project Intermountain Alta View Hospital Acute project no 19740.00

Rehab Unit

date 2021-01-21 no. pages

End of Addendum 003

3.2 AD110.1 **DEMOLITION PLAN - LEVEL 1 / LEVEL 2**

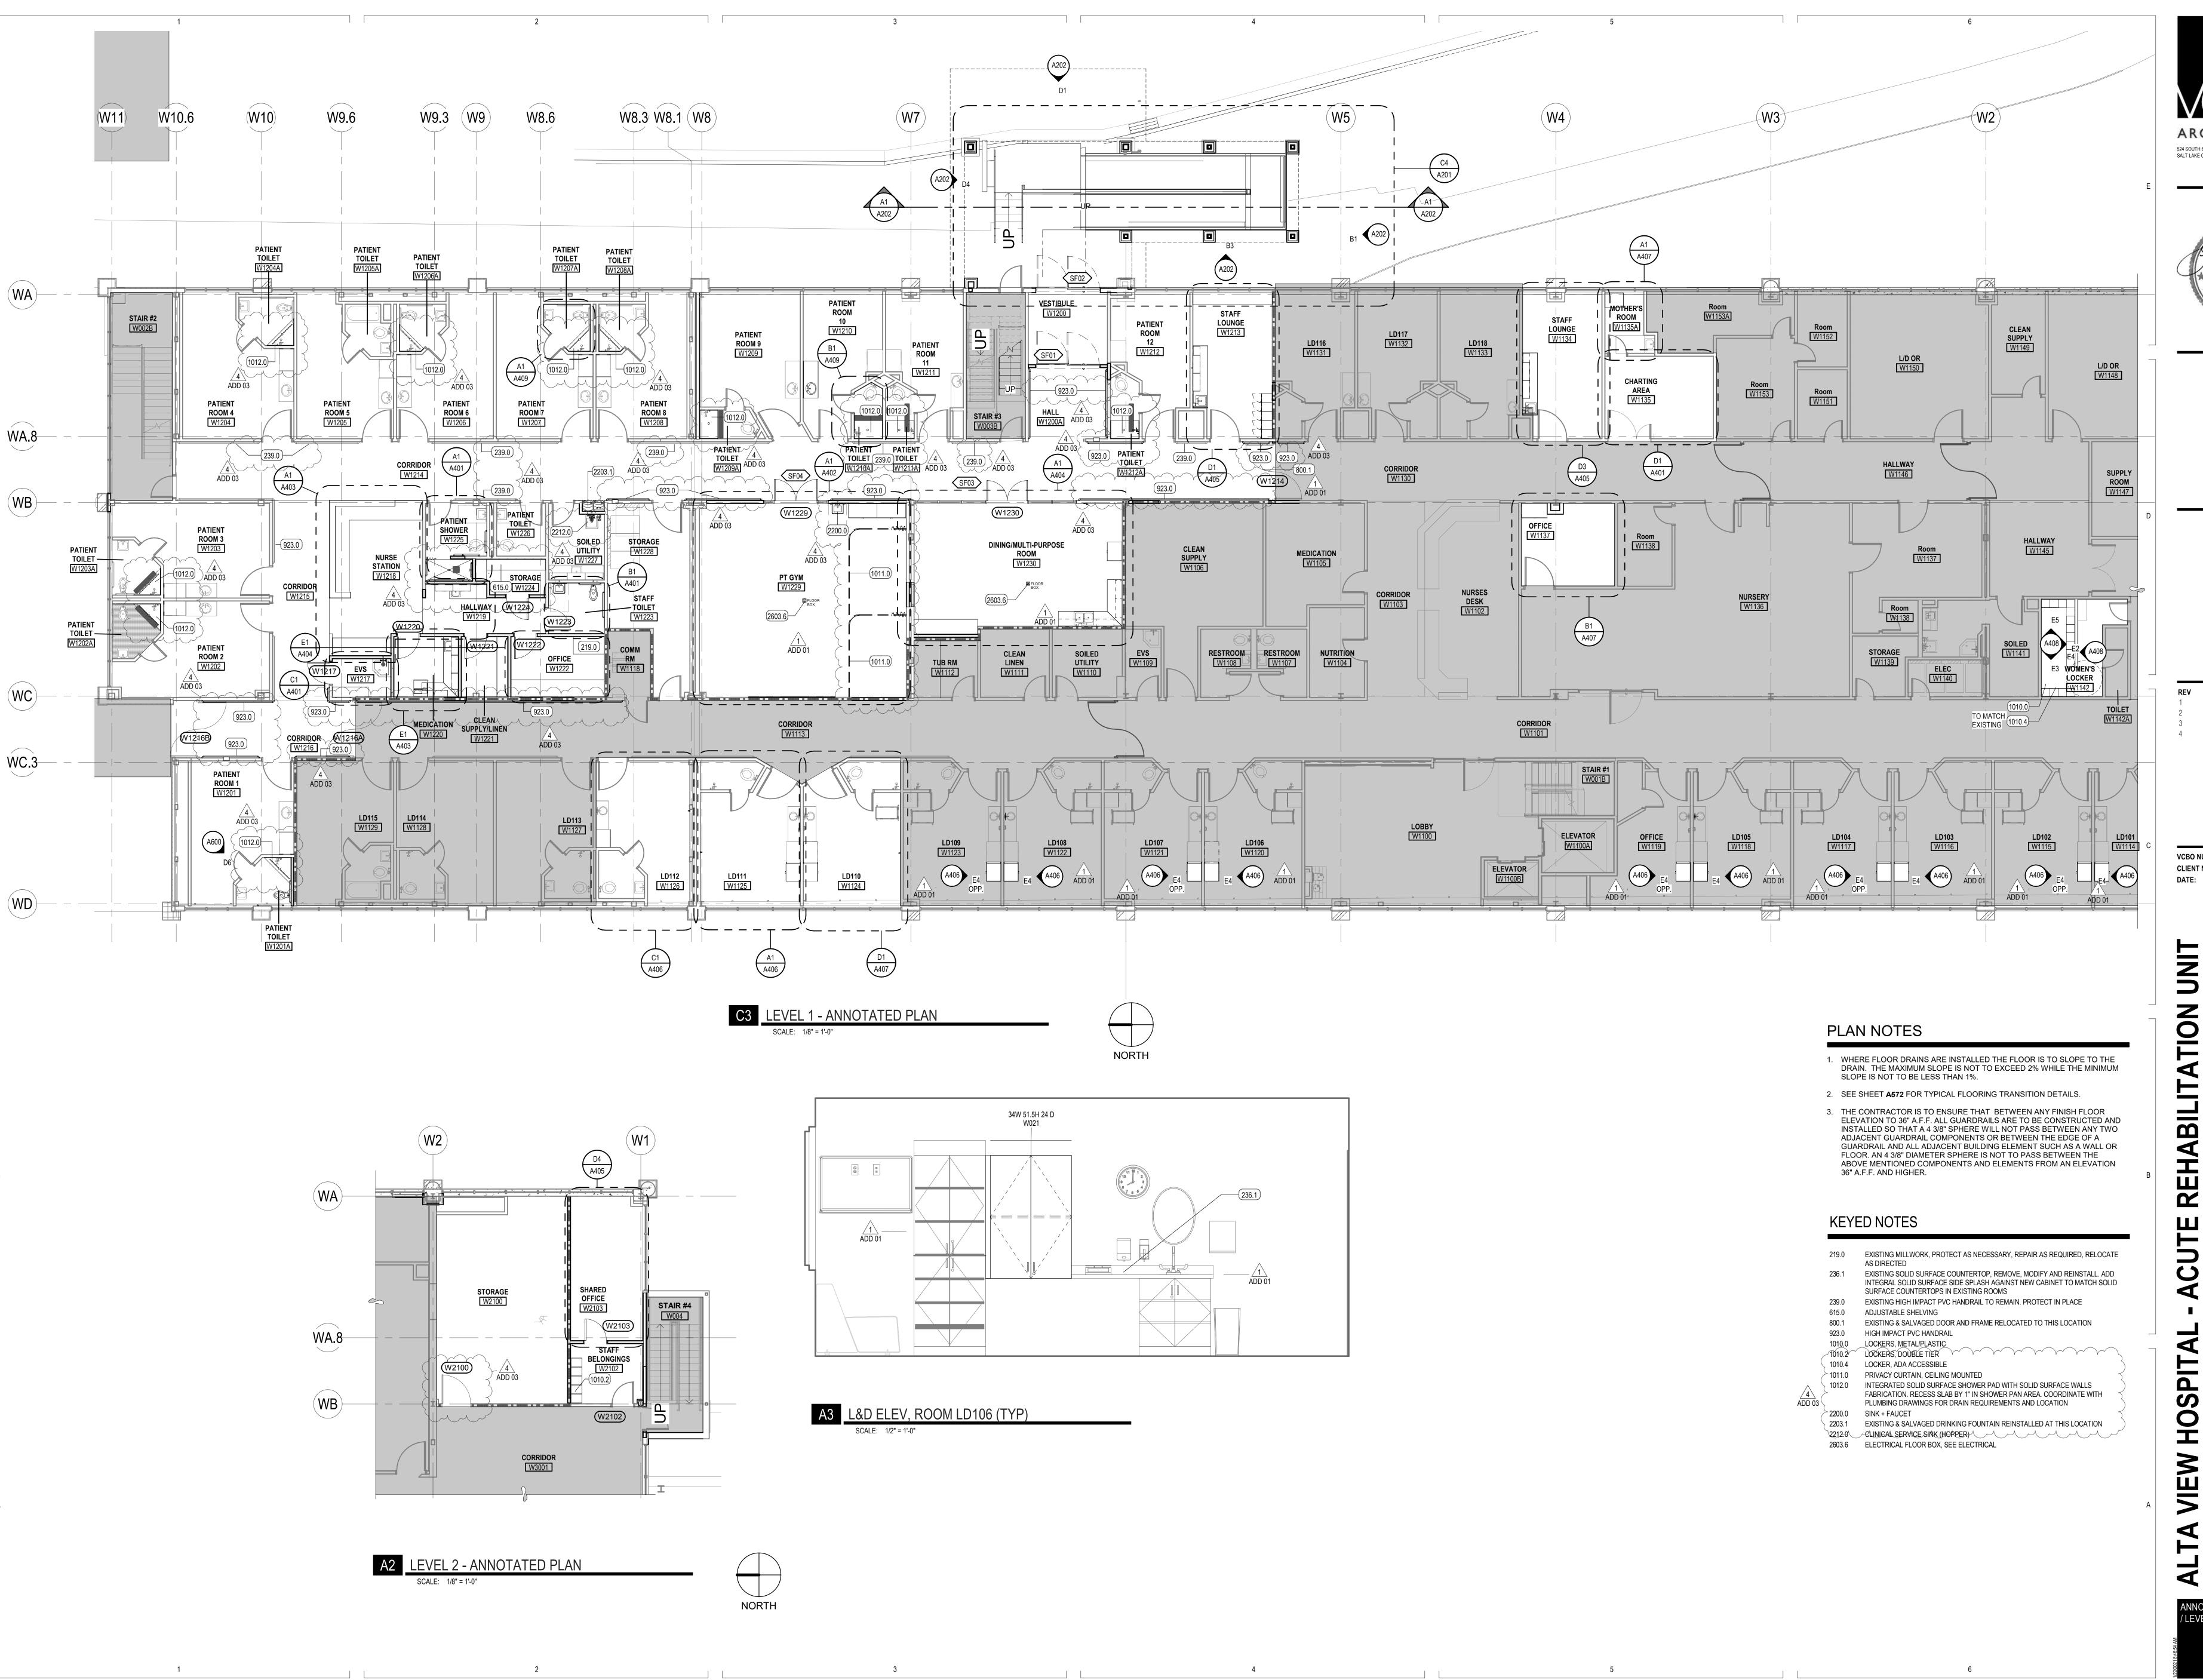
REFER to revised plan of Patient Toilet Type 1 showing the new demolition scope of work for the new integrated shower pan: REVISED keynote 234.1.ADDED keynote 225.1 in Patient Toilet Room Type 1.ADDED keynotes 222.1 and 240.0 in Patient Toilet Room Type 2.

A1 ENLARGED PLAN - PATIENT TOILET, TYP.

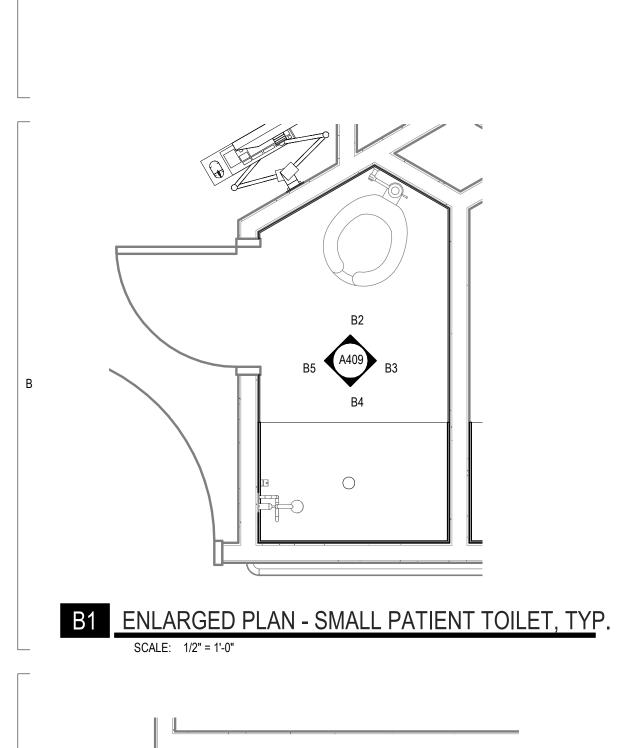
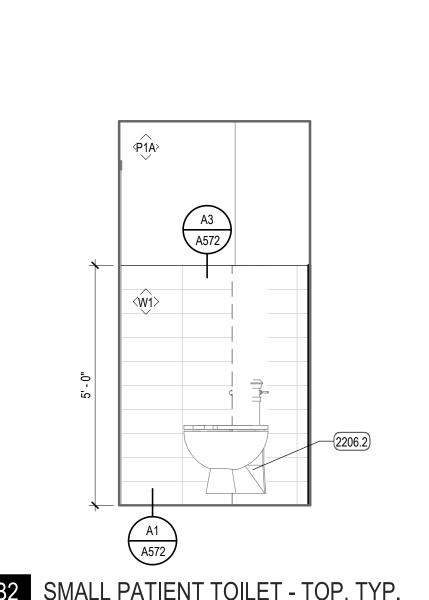
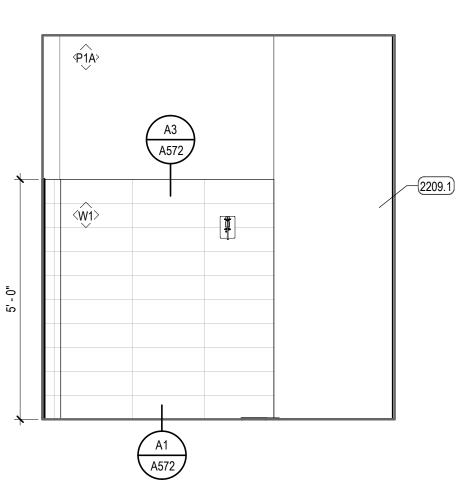
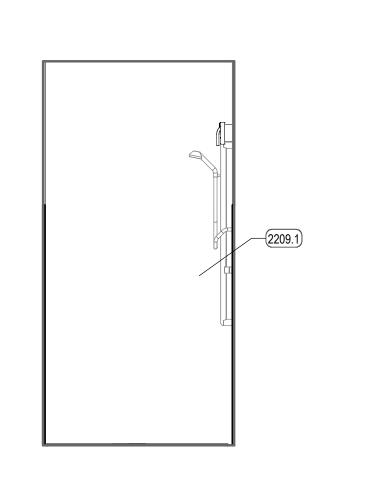
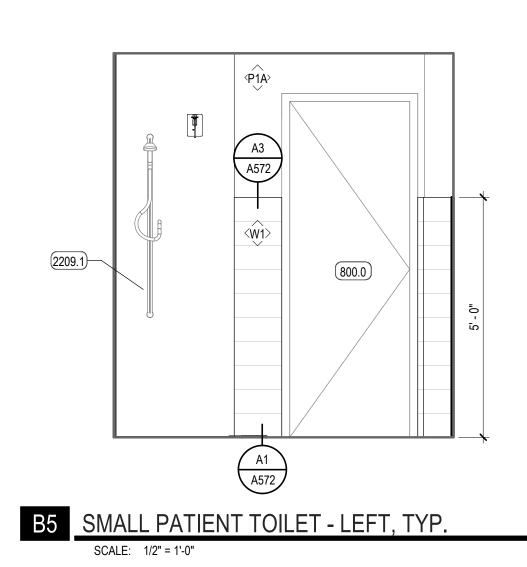
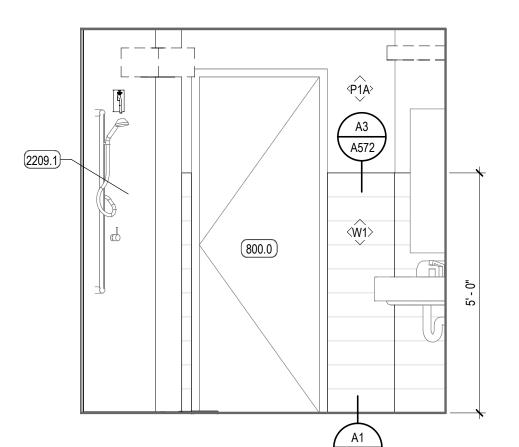
2. UPDATED wall base detail call-outs (for clarity).
ENLARGED PLANS + ELEVATIONS
1. ADDED new sheet to the project.
2. REFER to revised finishes in all Patient Toilet rooms: NEW integrated solid surface
shower pan with solid surface walls (recessed). REFER to demolition plans for
additional information.NEW wall tile and new floor tile in all Patient Toilet rooms.
EXTERIOR DETAILS

PLUMIBNG DEMOLITION PLAN - LEVEL 1

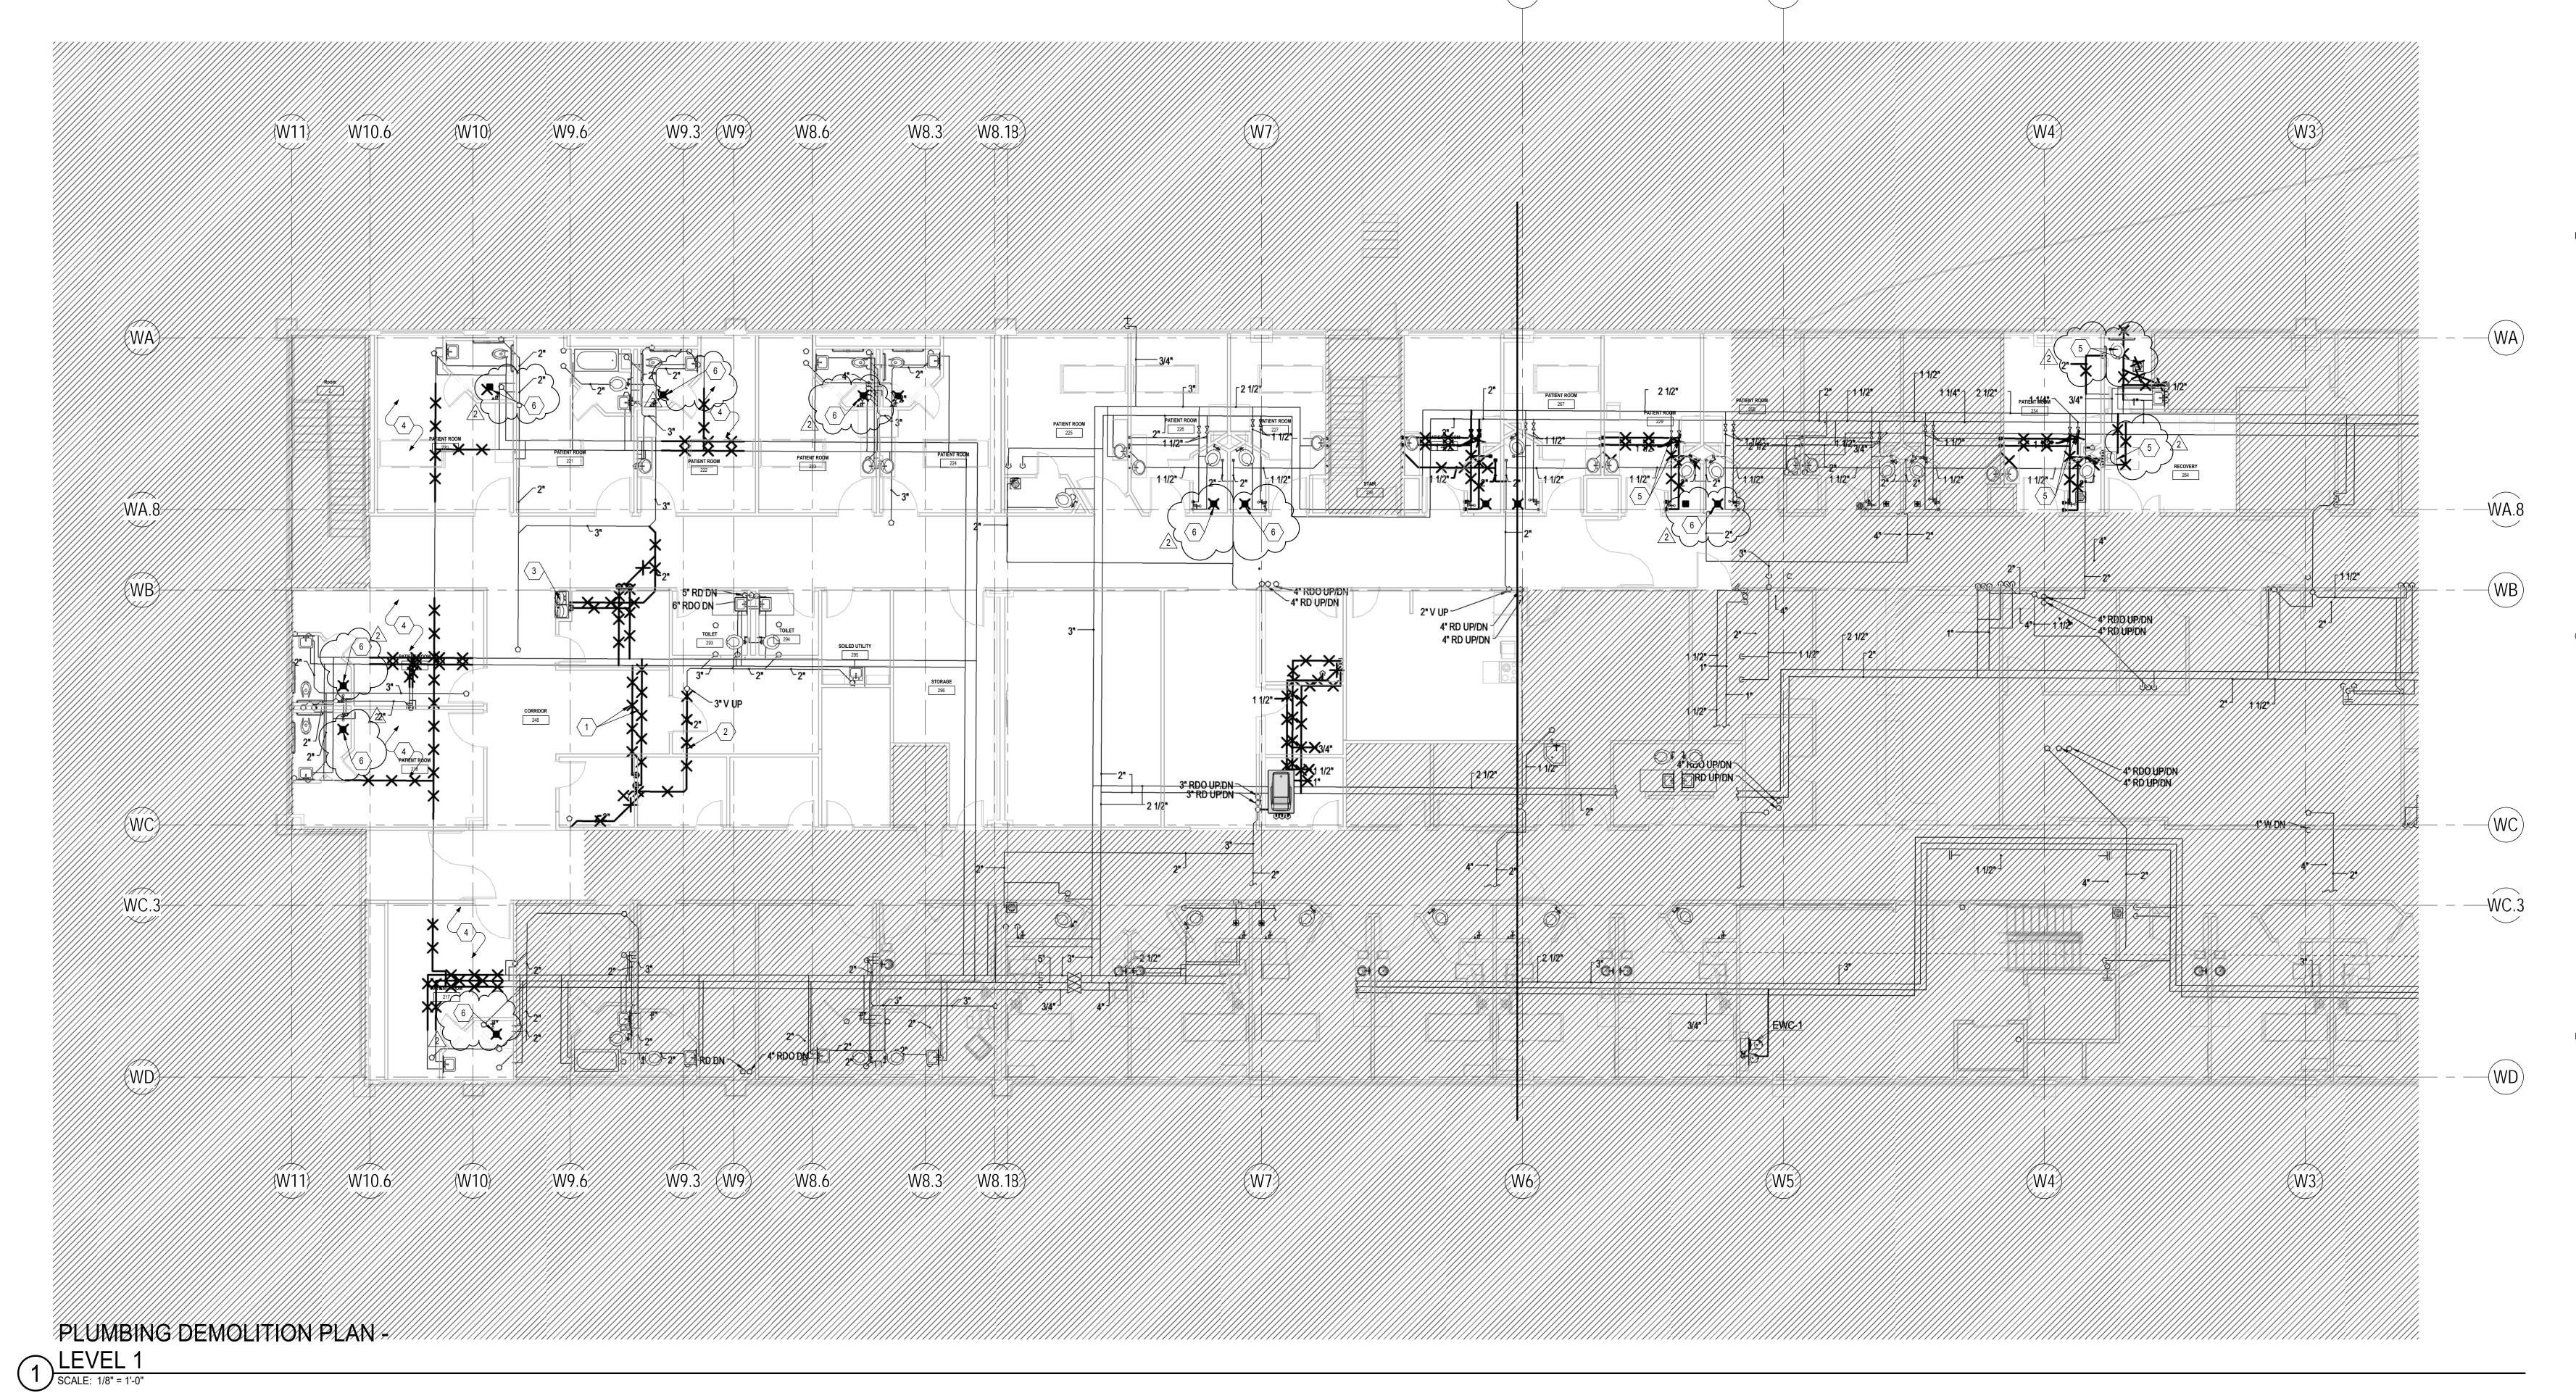
- 1. Existing shower drains are shown to be removed from various patient toilet rooms.
- 2. Added keynote #5 to plumbing fixtures at Recovery 264 and toilet room.
